ADDENDUM NO. 1

REPLACE ROOF SYSTEMS, MULTIPLE ASSETS
FARMINGTON CORRECTIONAL CENTER
FARMINGTON, MISSOURI
PROJECT NO. C1922-01

Bid Date: 1:30 PM, Tuesday, July 28, 2022

EXISTING RAFTER REPAIR DETAIL

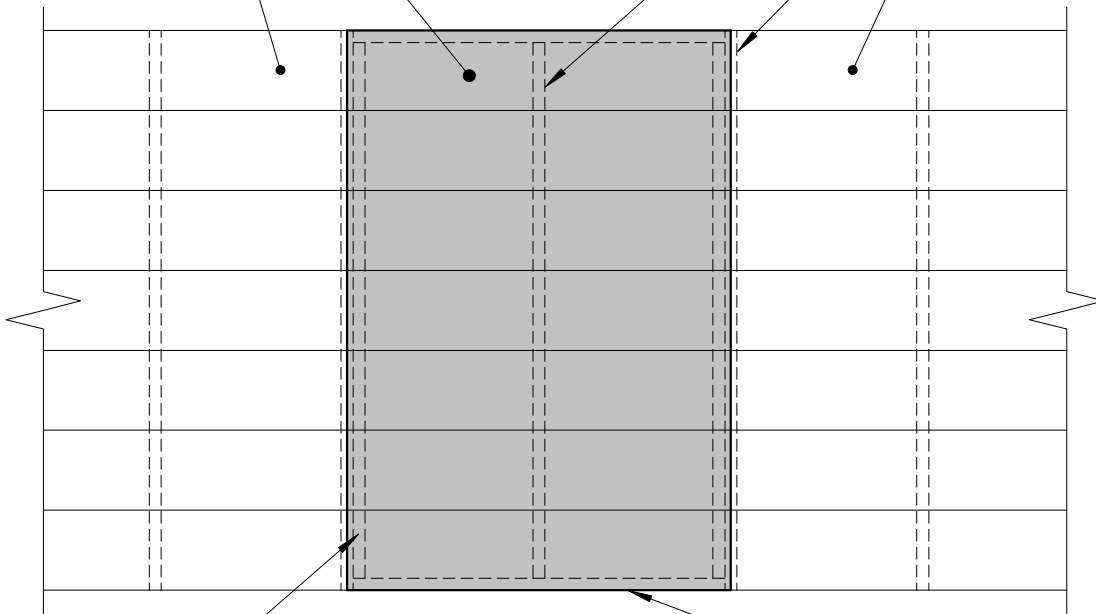
2. SHEET S000

- a. ADD Detail 2 Attached.

1. CONTRACTOR TO PUT IN BASE BID AN ALLOWANCE TO REPLACE 5% OF THE EXISTING ROOF RAFTER ENDS AT BUILDINGS 16, 17, 18, 19, 31, 32, AND 33 TO ACCOUNT FOR DAMAGED ROOF RAFTER ENDS. APPROXIMATE SQUARE FOOTAGE ASSUMED IS ± 2500 SQ FT. AREAS OF DAMAGED ROOF RAFTERS MUST BE REPLACED PRIOR TO INSTALLING THE NEW ROOFING SYSTEM. LOCATIONS WILL BE FIELD VERIFIED ONCE THE EXISTING ROOFING SYSTEM IS REMOVED AND STRUCTURE IS EXPOSED. DAMAGED PLANK DECKING BEYOND ESTIMATE WILL BE HANDLED VIA UNIT COST.

1. Description: Remove existing unsatisfactory and/or damaged rafter ends and replace as indicated in structural detail 2/S000.
2. Unit of Measurement: Square foot of rafters removed/replaced
3. Base Bid Quantity: 2500 sf

TYPICAL ROOF DORMER INFILL DETAIL

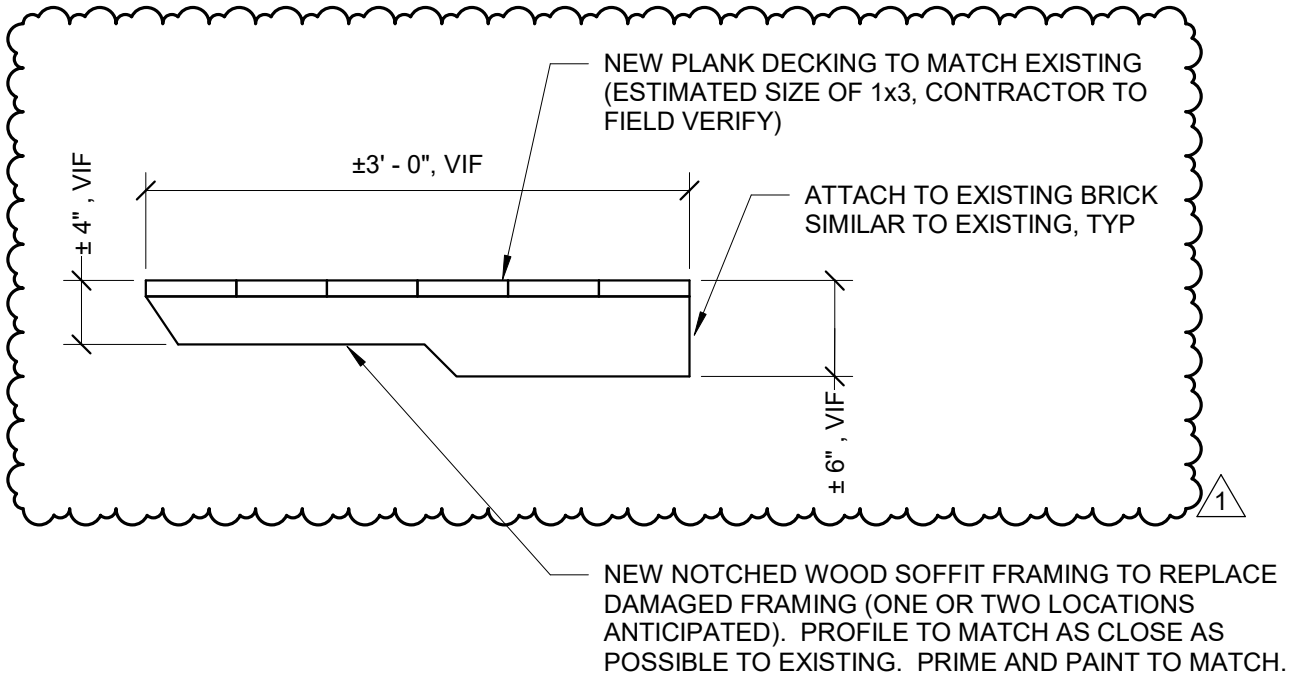
3. SHEET S101

- a. REVISE Detail 2 Attached

1. IF EXACT THICKNESS OF PLANK DECKING IS NOT AVAILABLE, MATCH TOP OF PLANK TO EXISTING AND SHIM NEW AS NECESSARY. EXISTING PLANK ASSUMED TO BE 1x PLANK OF VARYING WIDTHS. 1
2. ATTACH ENDS OF NEW 2x8 JOISTS TO PERPENDICULAR FRAMING WITH SIMPSON LUS HANGER.

SOFFIT FRAMING REPAIR DETAIL

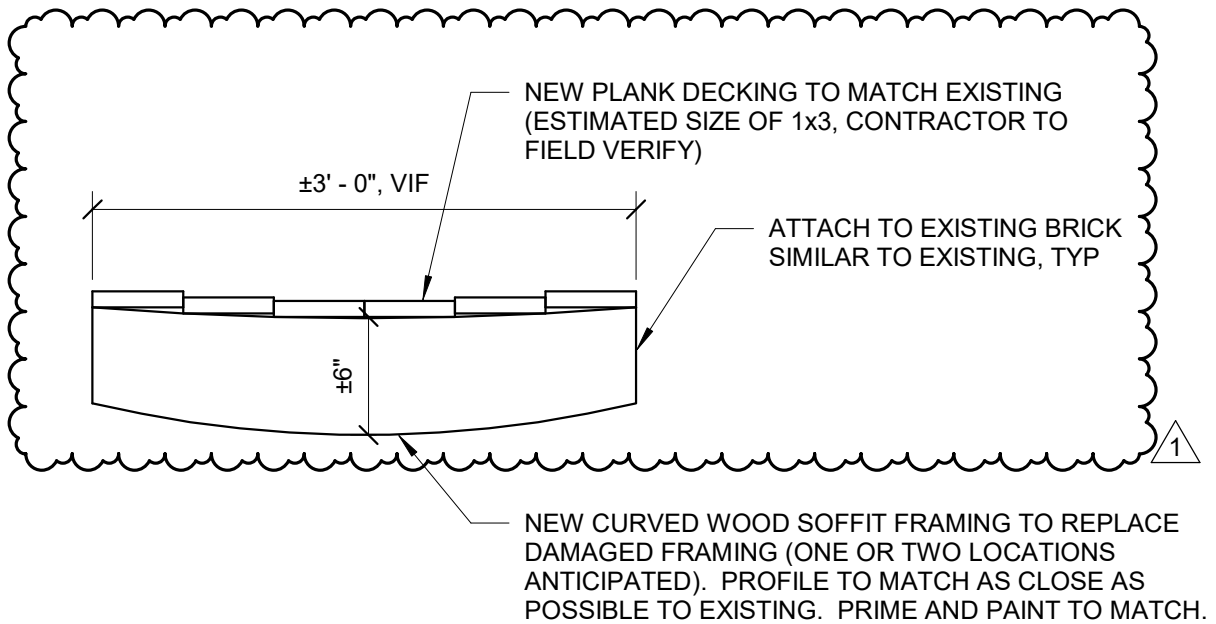
4. SHEET S102

- a. Revise Detail 2 Attached

1. NEW WOOD SHOULD BE PRESERVATIVE ¹ PRESSURE TREATED PRIOR TO PAINTING.
2. ATTACHMENT OF NEW SUPPORT TO BUILDING FRAMING SHALL MATCH EXISTING.
